**PROJECT: MIDDLE SCHOOL MEDIA CENTER RENOVATIONS
AL STANBACK MS, GRAVELLY HILL MS, ORANGE MS**

CRA PROJECT #: 2601.01, 2601.02, 2601.03

DATE: 4/1/2026

MODIFICATIONS TO THE CONTRACT DOCUMENTS FOR THE ABOVE-NAMED PROJECT SHALL BE MADE AS DESCRIBED BELOW AND SHALL BE INCLUDED IN THE BID AMOUNTS:

2 REFLECTED CEILING DEMOLITION PLAN - FIRST LEVEL
1/8" = 1'-0"

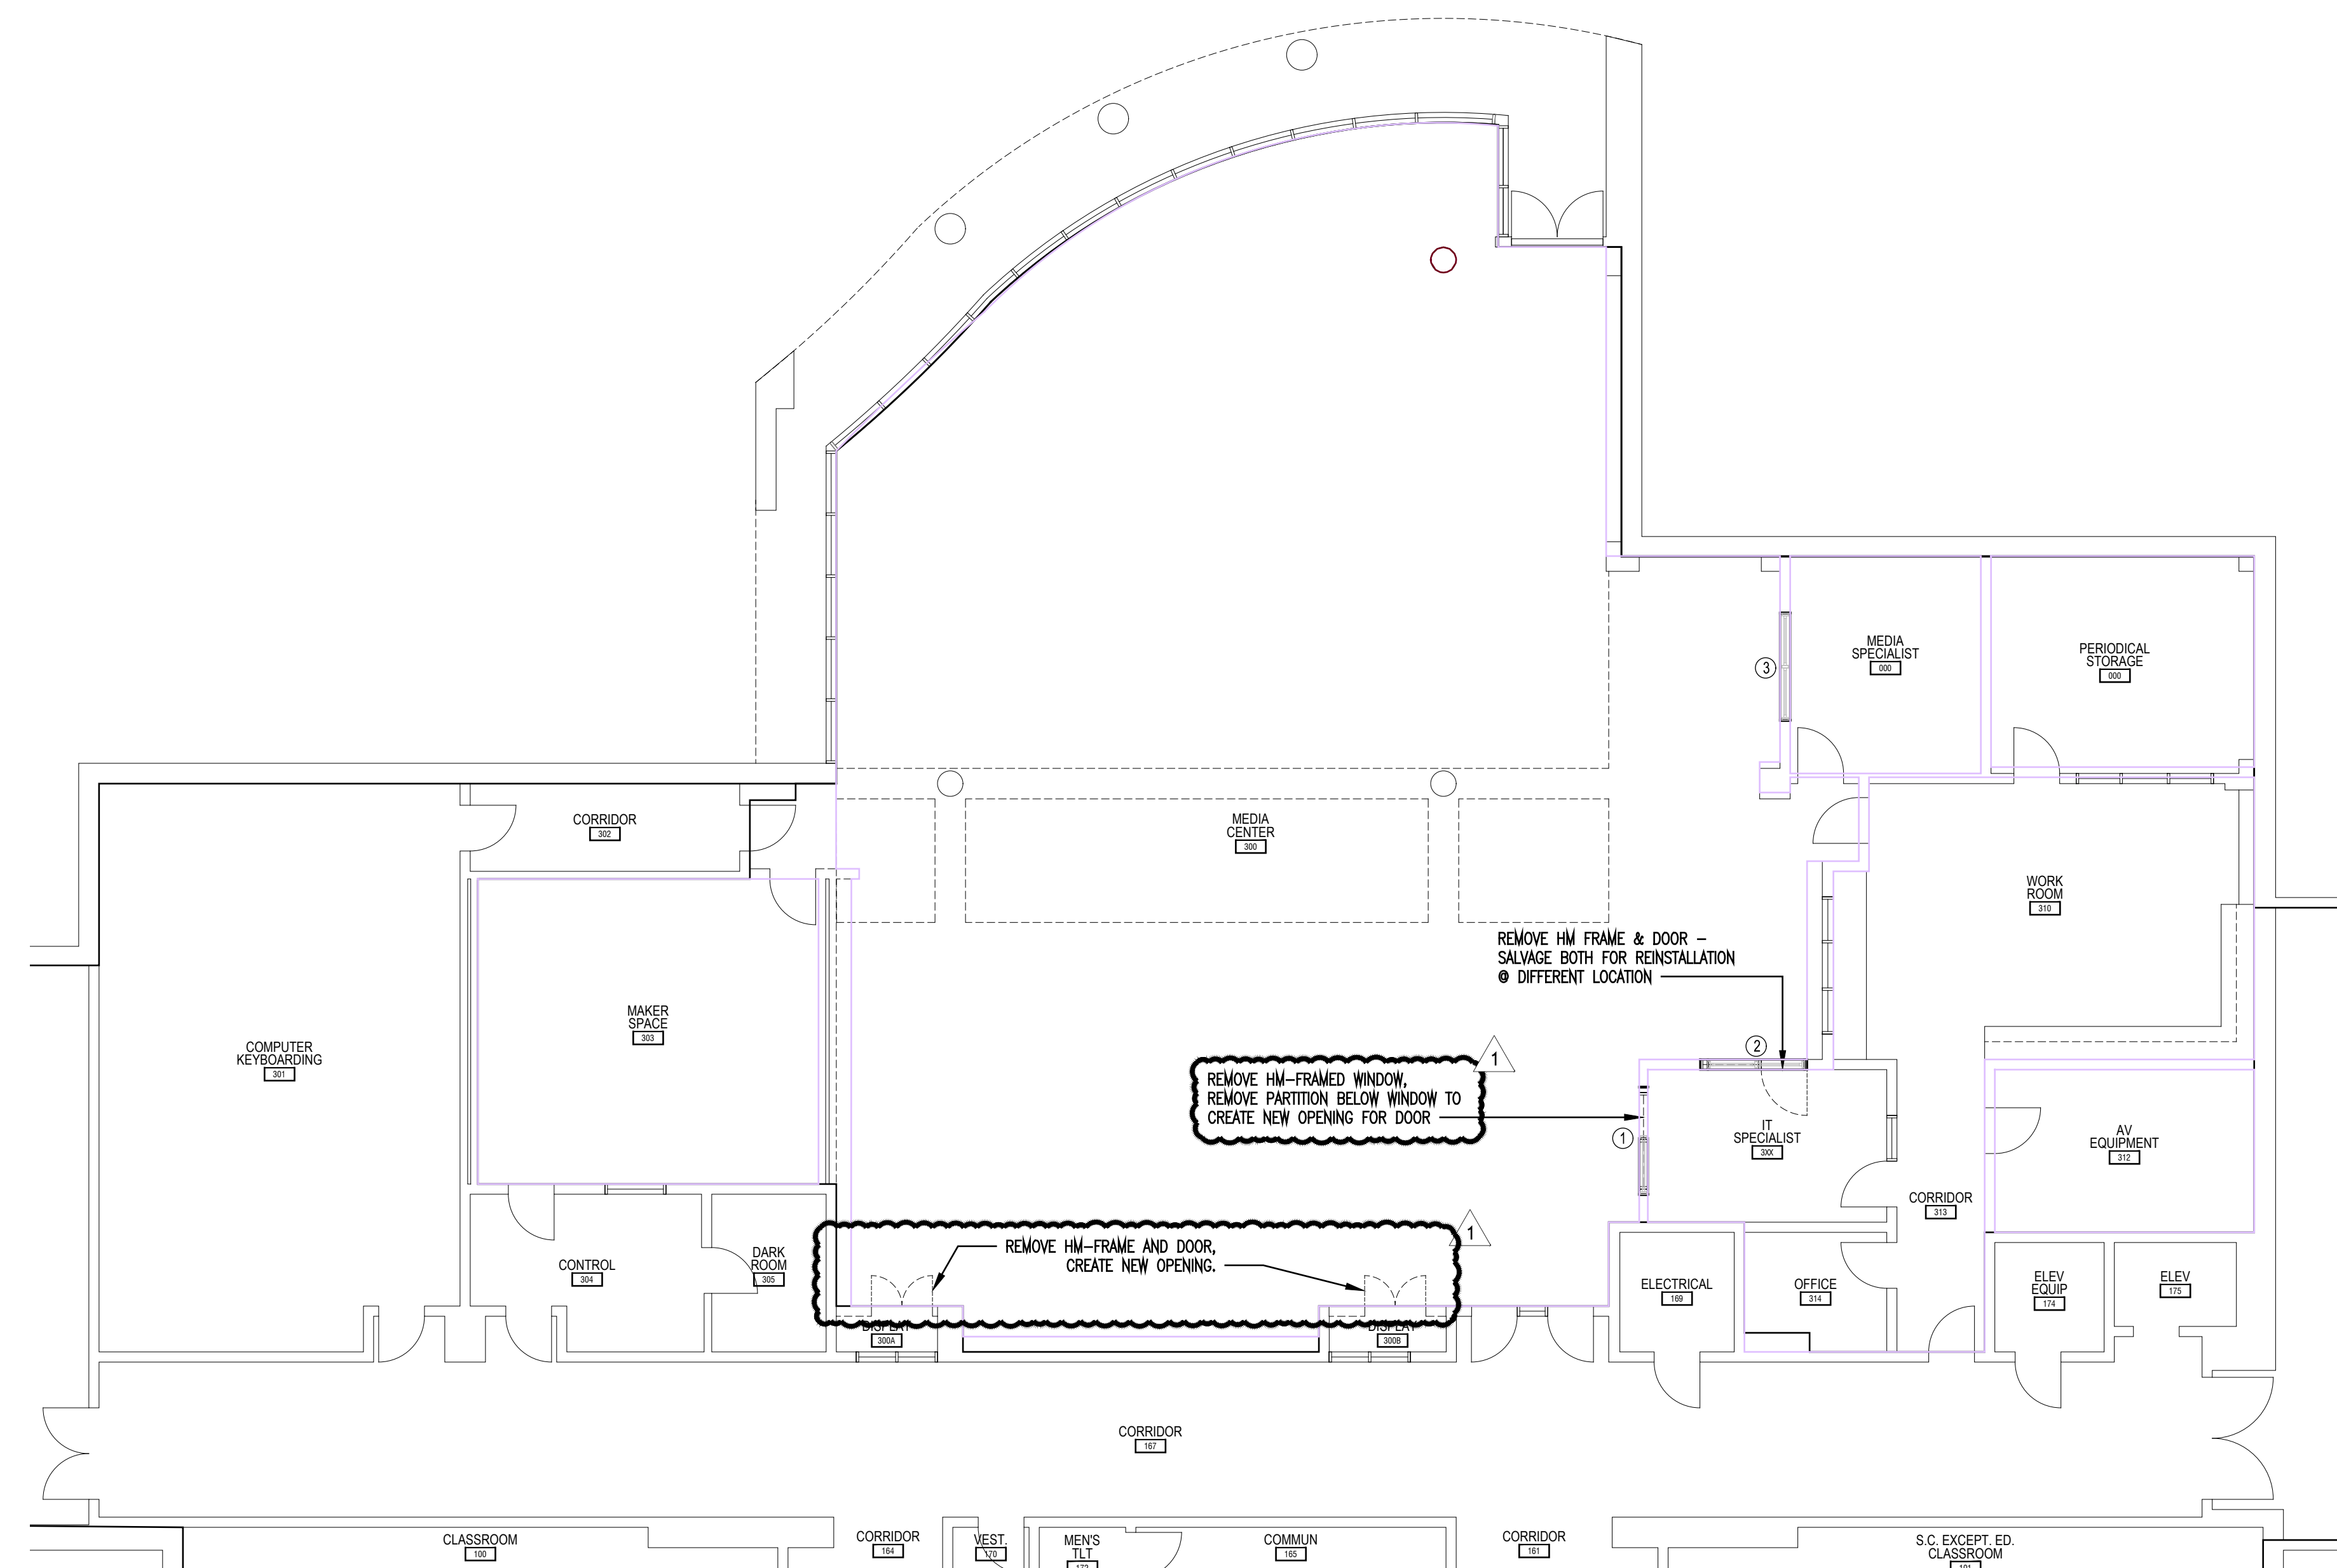
27	AL Stanback Gravelly Hill Demo Media Cases	Reference revised dwgs for AL Stanback--Contractor shall demolish doors and frames and provide sheetrock cased openings and soffits at former display cases. Prep and paint all sides of HM window frames.	4/1/26	
End of Clarifications			4/1/26
